SAHAM TONEY NEIGHBOURHOOD DEVELOPMENT PLAN 2019 - 2036

SAHAM TONEY PARISH COUNCIL RESPONSE TO THE ADDITIONAL COMMENTS OF THE INDEPENDENT EXAMINER

28 APRIL 2021

Figure 1: Location points for width measurements taken on 14 April 2021

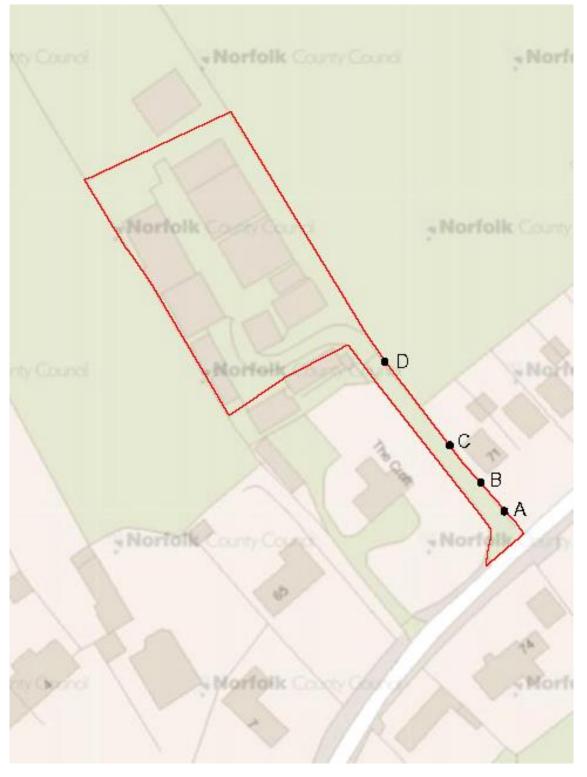
On my site visit, I was struck by the restricted width of the access. I was initially going to seek confirmation from Norfolk CC, as Highway Authority (LHA), there was sufficient width, to avoid vehicles having to reverse a considerable distance onto Hills Road. However, upon reading the AECOM Traffic Study, I was surprised to read that "The existing access width of circa 4.9m would safely facilitate two-way vehicle movements".

I attempted to measure the width, using Google Earth which seems to indicate a width of less than 4 metres but I accept that is less than accurate. Can I ask that the Parish Council measures the width, at a range of points, along the access way, between the edge of the hedgerow and the neighbouring fence and show the dimensions on a plan? That will then confirm or otherwise whether the conclusions of the AECOM report are correct

Policy Map 2F.2 shows a width of 4.9m as measured by AECOM close to the junction with Hills Road. It is not a requirement that such a site access road be 4.9m wide over its entire length. As required by P2I.1 (c), the access should be of width no less than 4.5m. That is in accordance with the Local Highways Authority's requirement, as set out in G2.5 of Norfolk County Council's guidance document 'Safe, Sustainable Development' (November 2019), which stipulates "Shared driveways shall have a minimum width of 4.5m over a length that extends into the site for a distance of 10m from the highway boundary".

With the permission of the landowner, on 14 April 2021 we took measurements of the existing access road widths, at four points along the road's length. Those points are shown on Figure 1. Their approximate distances form the junction with Hills Road and corresponding widths are tabulated below and show that the LHA width requirement may be complied with.:

| Position | Approximate distance from junction with Hills Road | Access road width |
| A | 5.0m | 5.0m |
| В | 18.0m | 4.85m |
| С | 32.0m | 4.5m |
| D | 60.0m | 4.5 |
